Change Order

PROJECT (Name and address): City of Jonesboro New Facility Sanitation and Street Jonesbor, AR	CHANGE ORDER NUMBER: 001 DATE: October 14, 2010	OWNER: <input checked="" type="checkbox"/> ARCHITECT: <input checked="" type="checkbox"/> CONTRACTOR: <input checked="" type="checkbox"/> FIELD: <input type="checkbox"/> OTHER: <input type="checkbox"/>
TO CONTRACTOR (Name and address): Bailey Contractors, Inc. 101 CR 130 Bono, AR 72416	ARCHITECT'S PROJECT NUMBER: 1-3628-08 Shop CONTRACT DATE: CONTRACT FOR: General Construction

CITY OF JONESBORO
VEHICLE MAINTENANCE FACILITY
 JONESBORO, AR

FLOOR PLAN

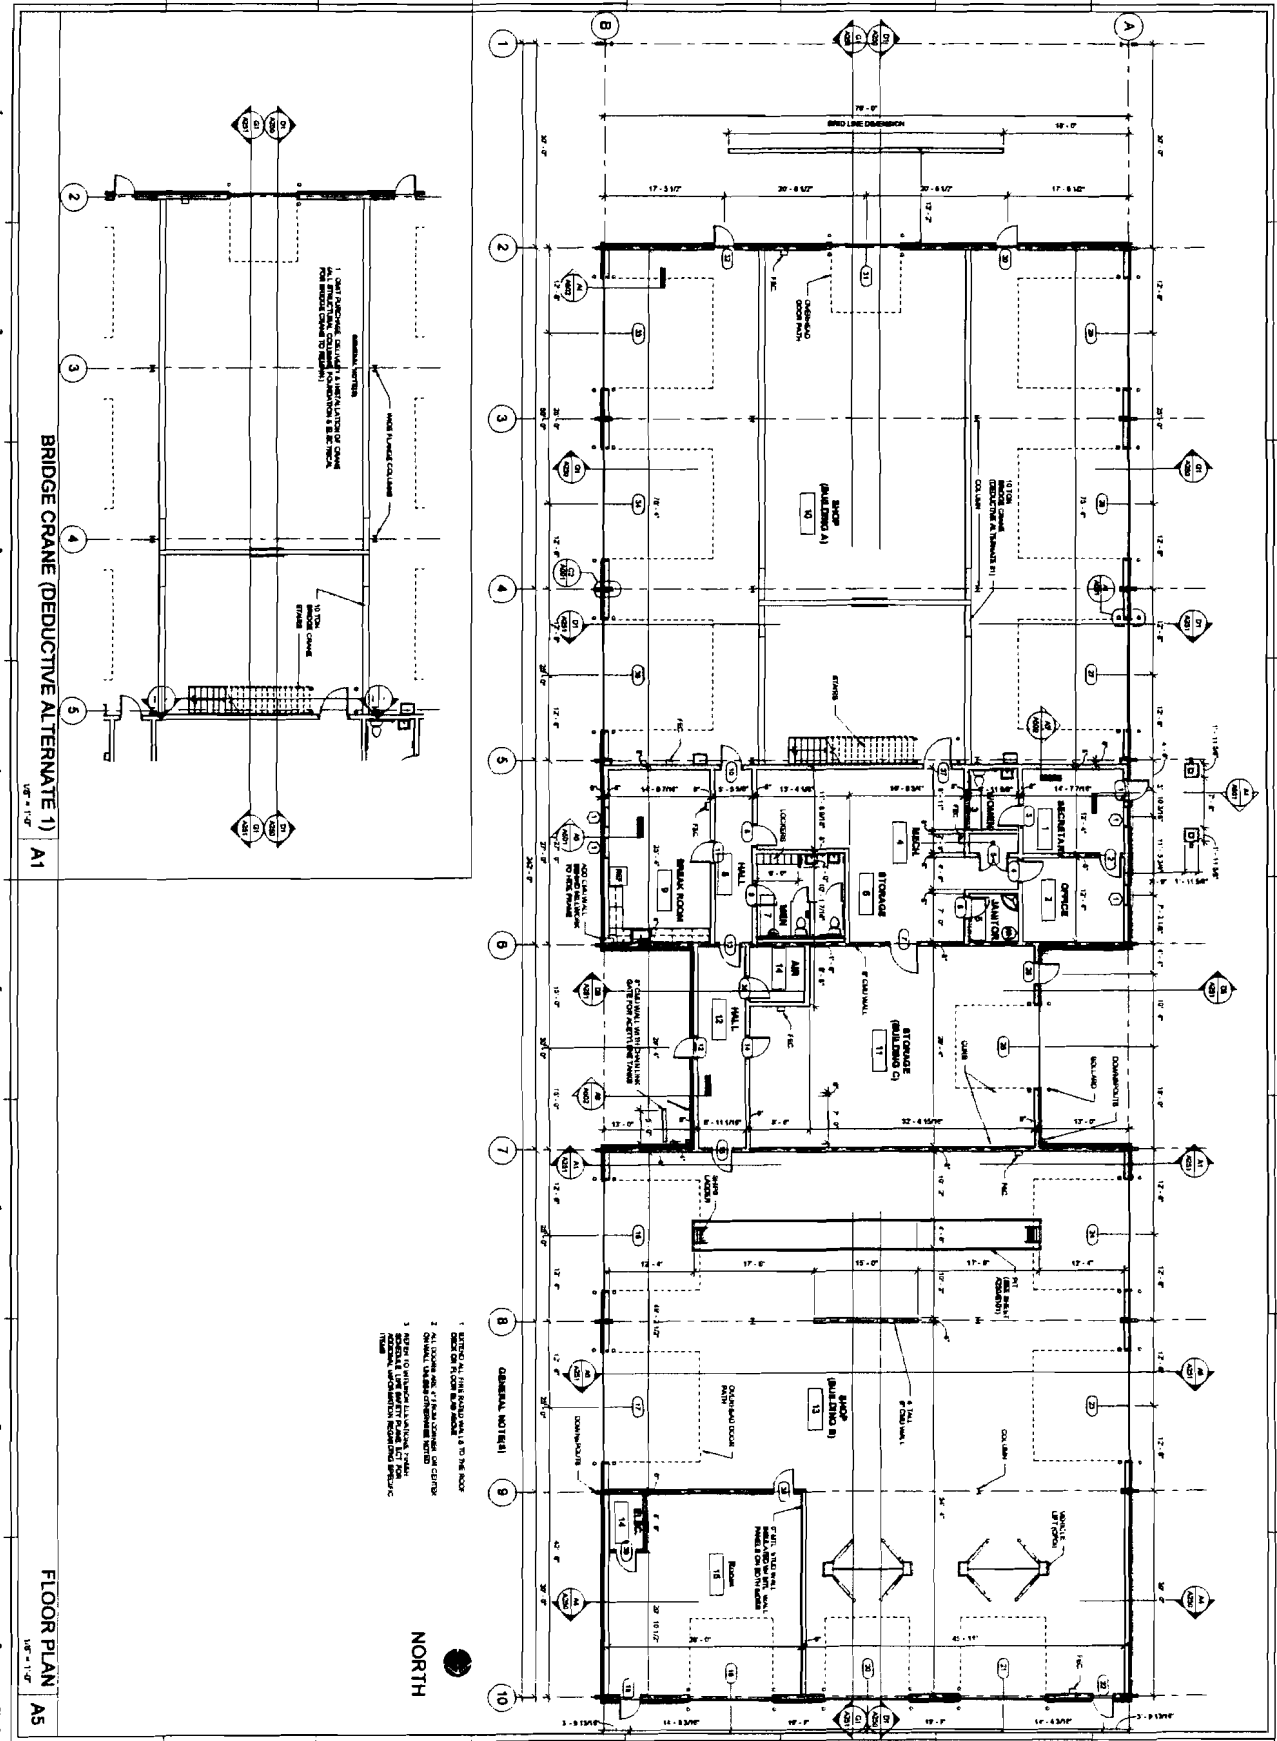
The 4" thick slab in grid lines 1 through 2 to be changed to a 8" thick slab. The 4" thick slab in grid lines 2 through 5 to be changed to a 8" thick slab. The 4" slab in grid lines 5 through 10 to be changed to a 6" thick slab. See attached drawing for grid line placements.
